Response to Highways Comments

Hinckley & District General Hospital, Mount Road

Project Number: 23013
Doc Number: TN02
Prepared for: NHS Properties

16 November 2023

Figure 3.1 Scope of Search

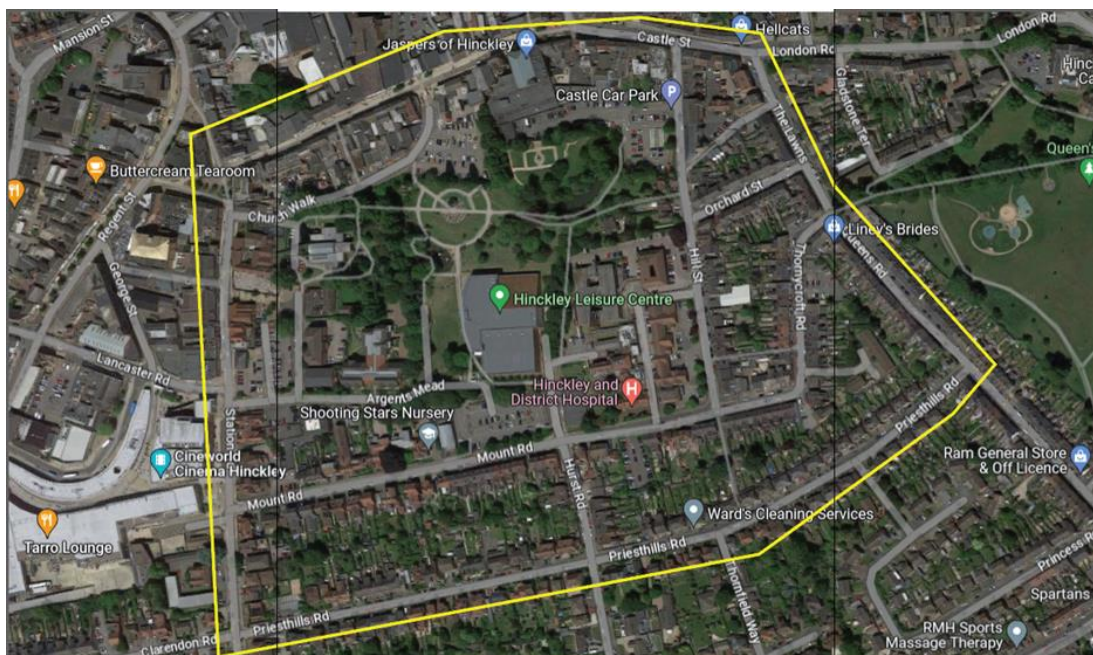
- Consideration of Personal Injury Collision data, it has been advised within the TS this is to be submitted to the LPA.
- Further clarity in respect of both existing and proposed staff and patient numbers at the development site and clarity as to how many staff/ patients will be on-site at any one time as a result of the proposals or would have been under the physio use.
- A first principles approach in considering trip generation, which could consider the level of vehicle trips the physio use could have generated during the AM and PM peaks as well as throughout the day in comparison to the proposals.
- Clarity in respect of parking provision and how this was operated under the physio use and how it would be operated under the proposed use, e.g., any staff parking allocations within the overall site and where patients would be directed to park.

3.1 A PIA collision data search was commissioned from LCC, which included all roads within the vicinity of the hospital. Including Hill Street, Mount Road, Argents Mead, Hurst Road, Castle Street, Station Road, Priesthills Road, Orchard Street, The Lawns, and Queen's Road, which are the roads which would be expected to carry the distribution of site traffic in the first instance. The scope of search is shown overleaf in Figure 3.1.

Figure 3.2 Results of PIA Collision Data Search

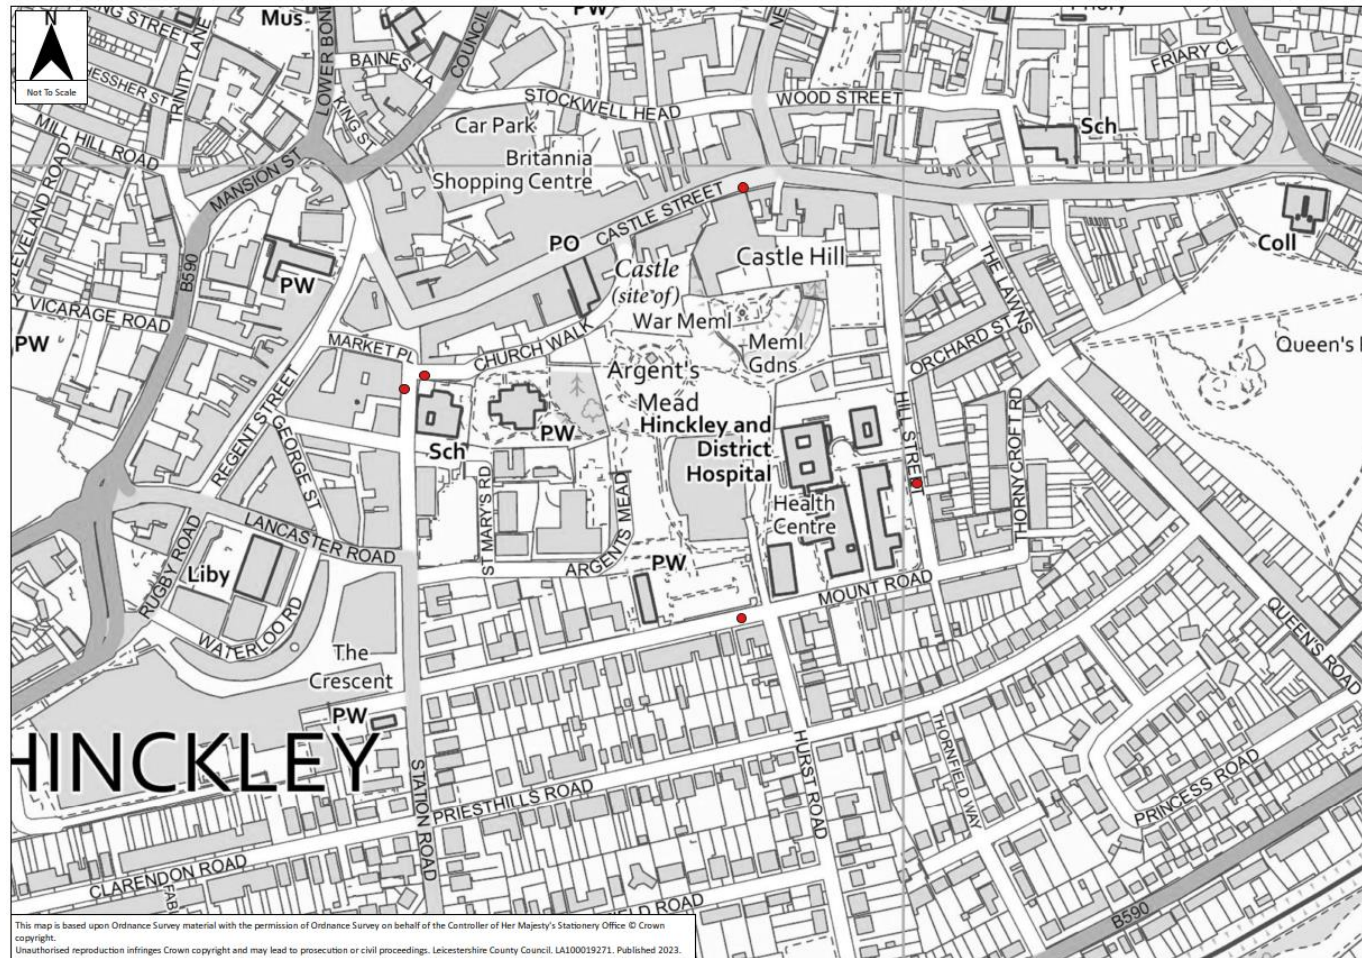
The Applicant states analysis of Personal Injury Collision (PIC) data for the surrounding highway network is pending at the time of writing. The LHA advises that this information is therefore still required. It is suggested the analysis considers PIC's along Mount Road and Hill Street. PIC data can be obtained from NDI@leics.gov.uk if necessary.

- 3.2 The search returned a total of 5 recorded collisions, which are shown diagrammatically overleaf in Figure 3.2.

- 3.3 The data encompasses all records from 2018-2023 up to the most recent record held. Each collision resulted in a single casualty. A summary of the frequency of collision by severity is provided in Table 3.1.

- 3.4 As shown, there were no recorded collisions in the area in 2022 or so far in 2023. Four of the recorded collisions resulted in slight personal injury casualties and the final collision in a serious injury.
- 3.5 All of the collisions occurred in dry conditions, and none involved a turning movement. Three collisions resulted in pedestrian injuries, including the serious casualty.
- 3.6 No factors are noted as potential causes for any collision; however, some appear to have been rear end shunts in slow moving traffic. The pedestrian movements are also not noted. However, there is no clear pattern of accident to suggest that there is a material design issue on any part of the local highway near to the site, and that the accident rate is low.
